**SOUTH WINDSOR PUBLIC SCHOOLS
TIMOTHY EDWARDS MIDDLE SCHOOL AIR CONDITIONING FOR (4) INTERIOR
CLASSROOMS**

RFP NO. 2023-007

Addendum No. 2 – January 4, 2023

- Update to S-101 Drawing Attached
- Answers to initial RFI's

1 PARTIAL ROOF FRAMING PLAN
S101 SCALE: 1/8" = 1'-0"

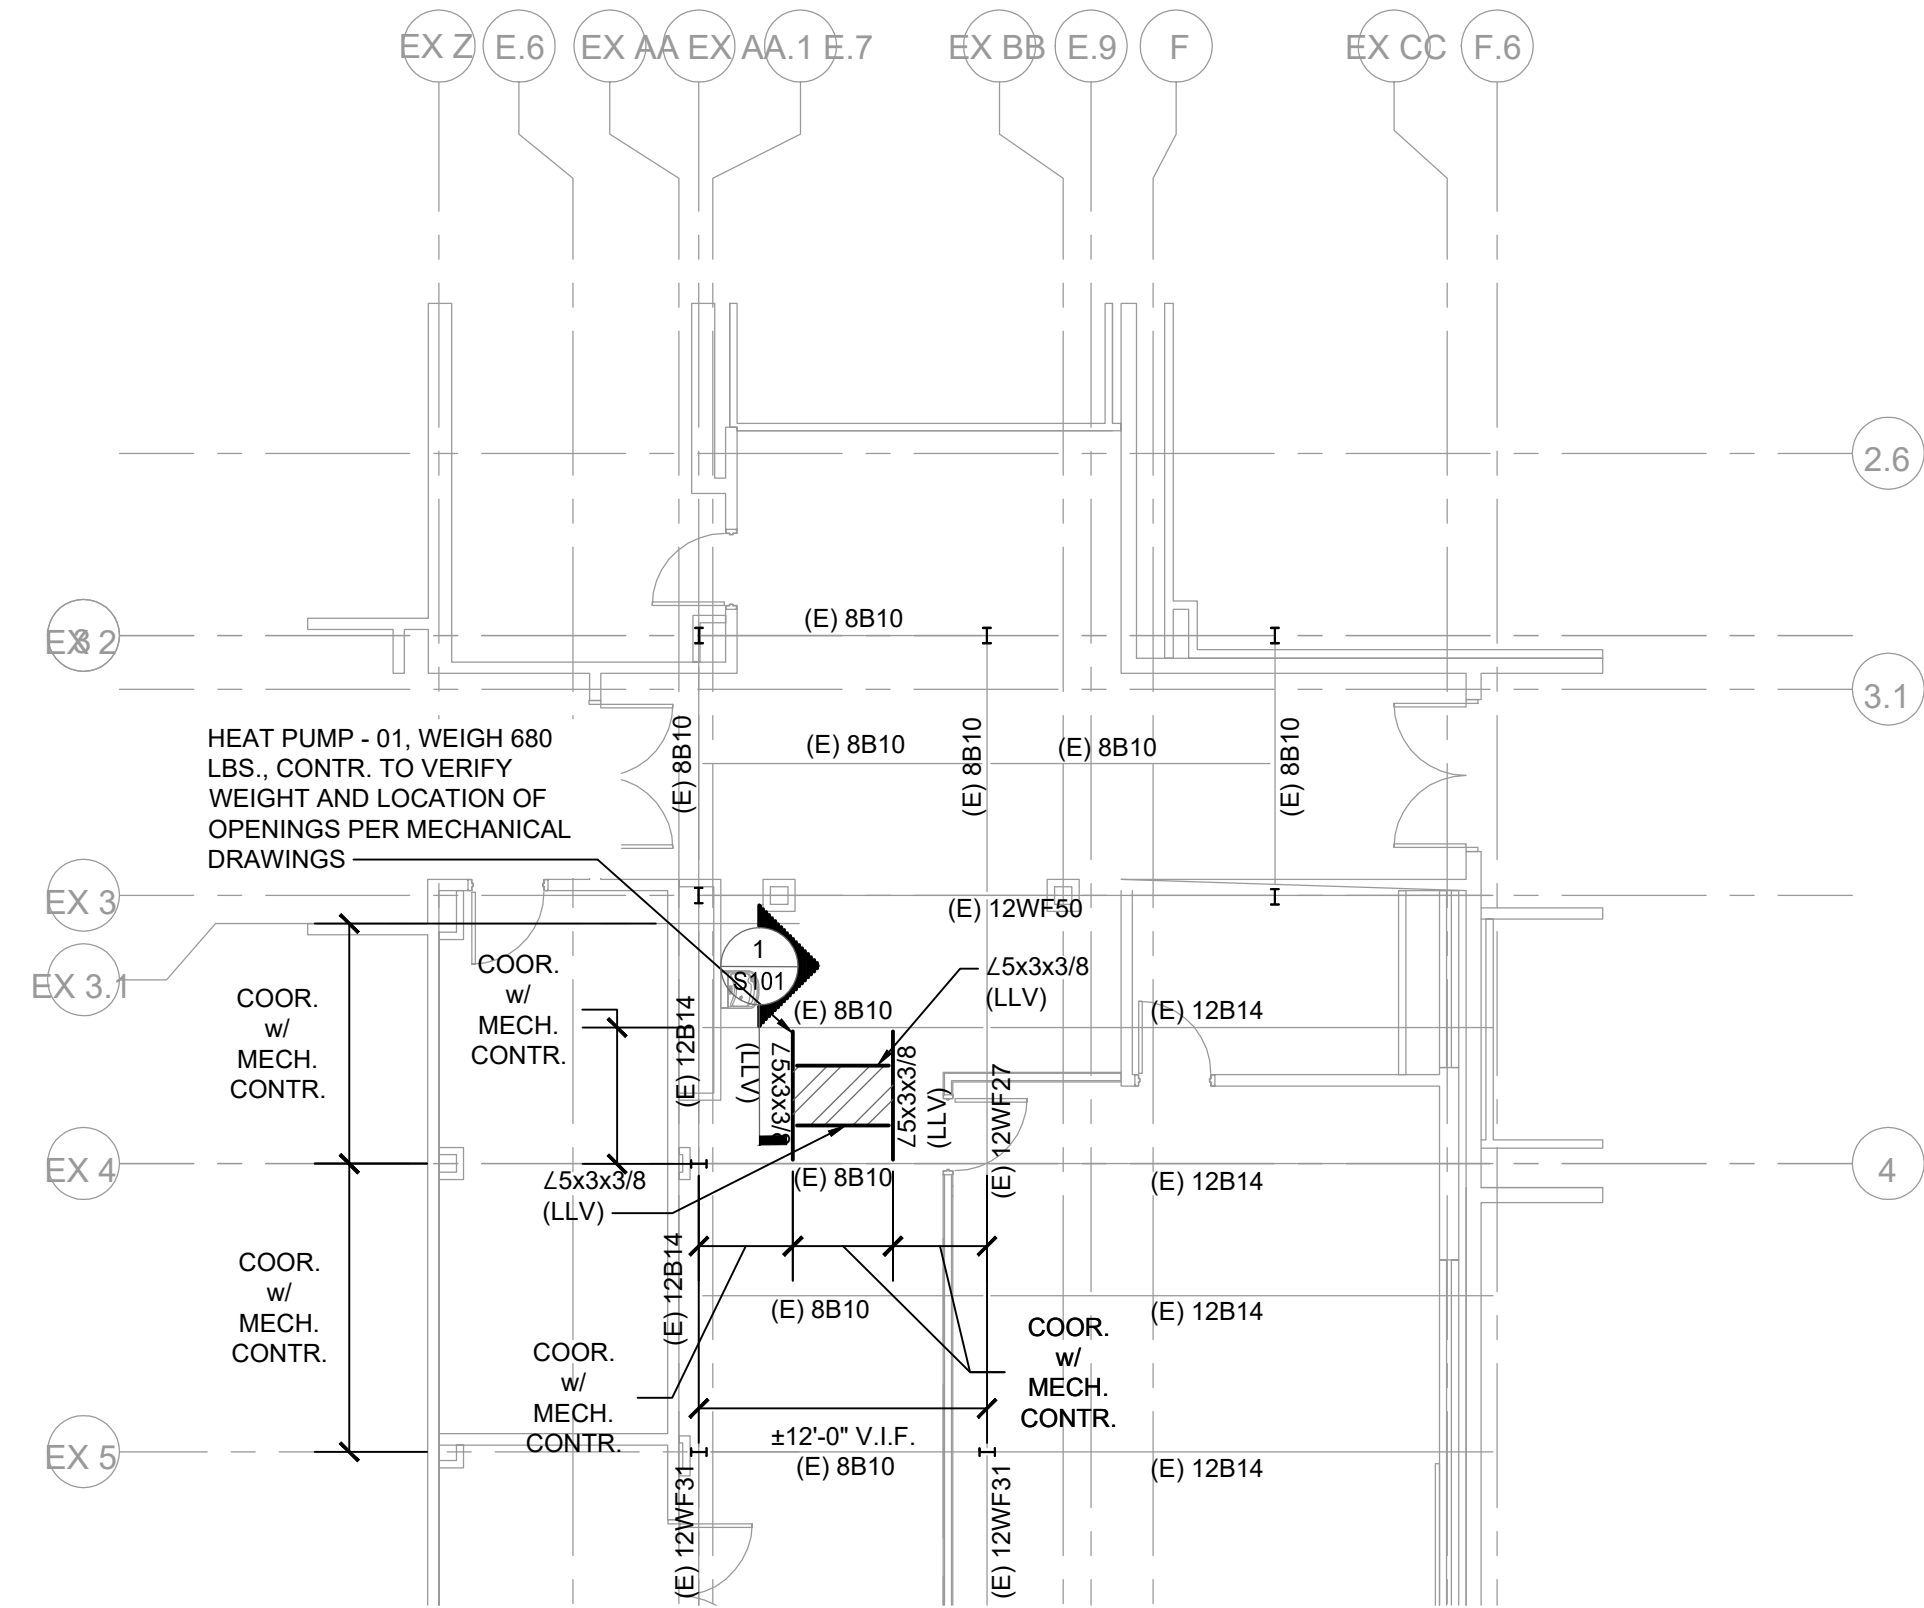
4.) **QUESTION:** I understand that the roof is no longer under warranty but can you tell me what kind/style the current roofing system is?

ANSWER: Following is roof information based on existing drawings, which is also added to S-101 drawing, the contractor should verify exact structure in field.
